MT PORTER
NORTHERN TERRITORY

PUBLIC ENVIRONMENTAL REPORT SUPPLEMENT

FEBRUARY 2007

ARAFURA RESOURCES

Figure 1: Pit Outline

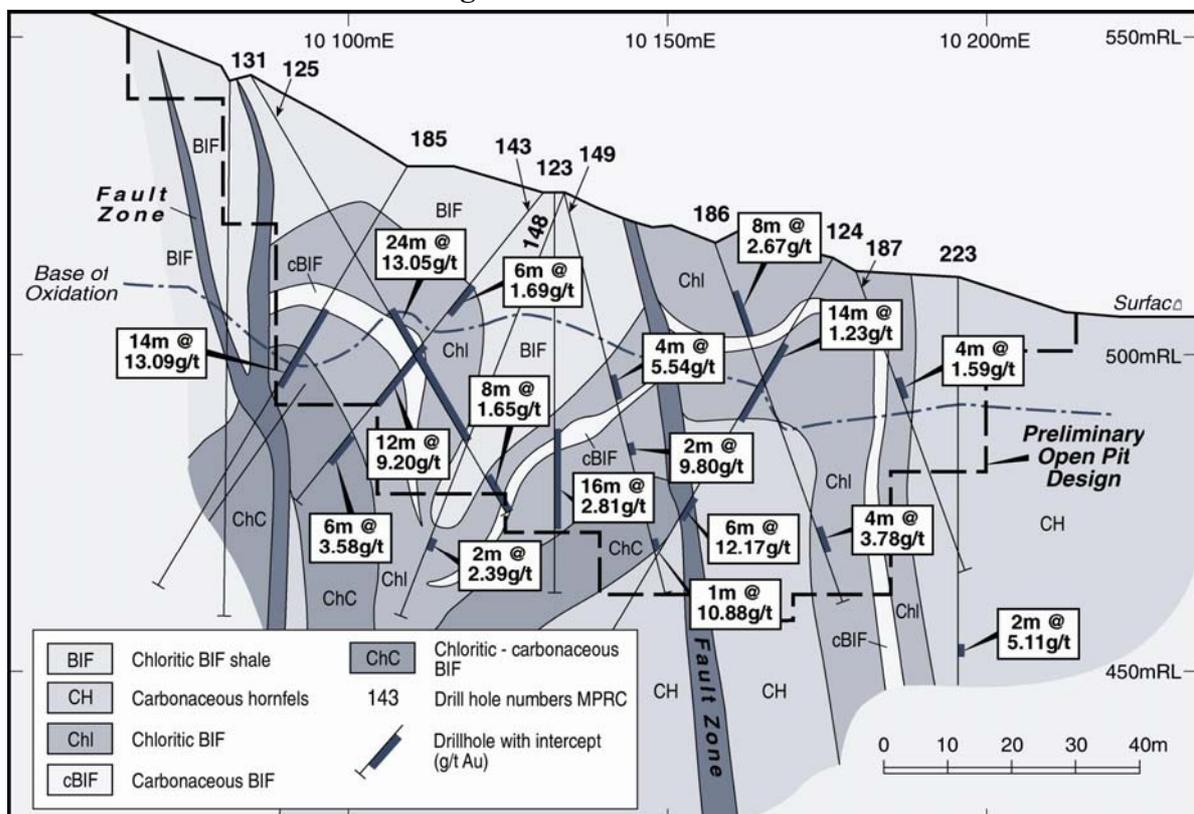
DPIFM: Section 4.5.1, figure 4: This diagram is intended to be a cross-sectional view of the open pit but does not appear to show the open pit profile. It is hard therefore to accept the statement in section 4.7 which states that 70-75% of the waste rock in the pit is oxidised. Fig 4 shows a large proportion of ore in the primary/sulphide zone.

The diagrammatic cross section shown in the PER was intended to present as much assay and geological data as feasibly possible. Figure 1 superimposes the pit outline over this cross section. The Base of Oxidation line shown confirms the top 20-40 metres of the pit is oxidised. This represents the widest part of the open pit conical shape and comprises the bulk of the waste material. The deeper zone, in the primary sulphide zone, contains the bulk of the ore, and thus a significantly smaller proportion of waste.

Figure 2: Waste Landform Upper Surface Drainage Design

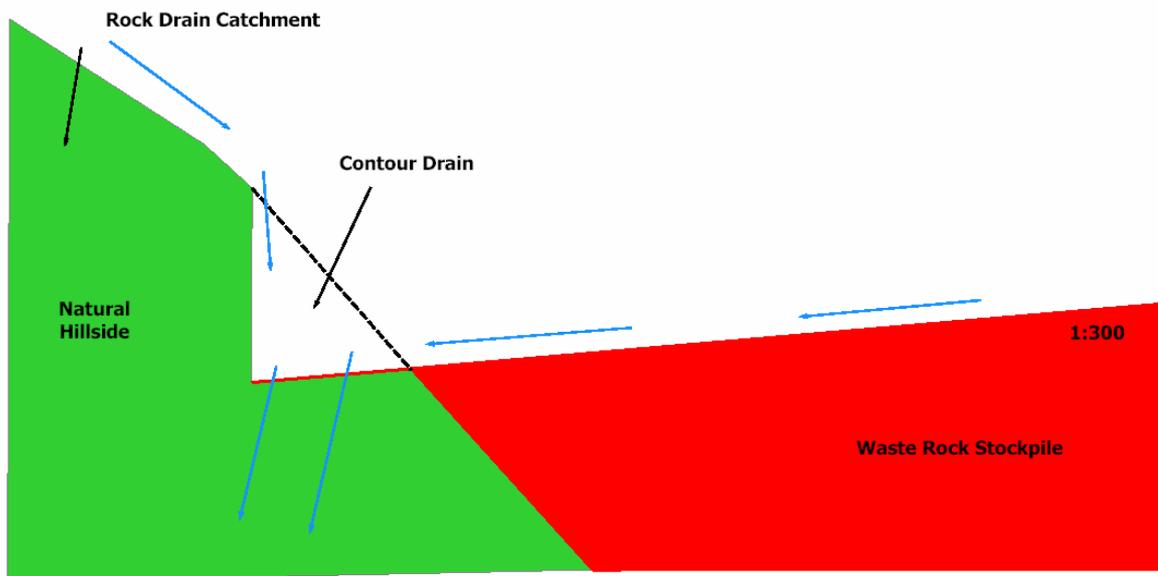
- ***Explain how new watercourses will be designed to inhibit surface water infiltration through the WRD.***
- ***Provide design detail of creek diversions around the waste rock stockpile, to explain how wet season sediment transport and erosion of the newly placed waste rock and topsoil will be prevented.***
- ***Specify design parameters of sedimentation basins and drains in terms of Average Recurrence Interval (ARI) rainfall events.***
- ***Predict the consequences of rainfall events exceeding ARI design thresholds.***

The EPA comment that rock armoured spillway structures proposed on the sides of the WRD (PER s.4.7) may potentially be subjected to peripheral erosion during high rainfall events, and end up perched above or beside the actual flow channels. They request the following information:

The new watercourse designs are shown in Figure 2 and Figure 3. Explanation of the design principles is as follows:

- The new watercourses (creek diversions) will be designed to avoid infiltration into the waste landform by constructing them into the side of the natural hillside, rather than on the top of the waste landform itself. The top of the waste landform will be designed to be water shedding on a gentle grade which will minimise surface water flow velocity and thus erosion potential (Figure 2).
- The new water course will also be designed on a gentle gradient, to similarly minimise water velocity along its length. Constructing the actual drainage channel into the natural hillside enables the drainage line to be constructed beyond the leading edge of the waste landform. Drainage off the waste landform is then directed down a rock armoured spillway, located totally onto the natural soil profile, not the waste landform (Figure 3).
